Product Change Notification (PCN)

PCN Number	501209	Date Issued	October 12, 2016
Reason for Change	Change to Product		
Change Type Description	This letter is to inform you that changes are being made to the part(s) identified in this Notice. The change will affect the fit, form, function or appearance of the parts. Or, it may result in a change to the specification. The pictures below show an example of the possible differences.		
Reason for Short Notice	New Capacity		
Assessment of Change	Test report/Specification Test Report		
Internal Molex Qualification Date	December 06, 2016		
Sample Availability Date (Changed Part)	December 06, 2016		
Planned Implementation Date	December 14, 2016		
Method of Identifying Change	Date code

**Molex Mini50 SMT
USCAR Update and Capacity Tools
Customer Notification**

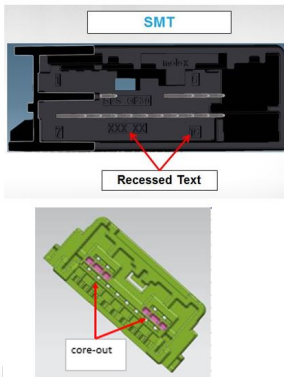
Based on a mandate from USCAR, the text in the floor of the SMT headers must be changed. The change will make the text "recessed" into the floor instead of "proud" of the floor. This will have no change to fit or function of the product.
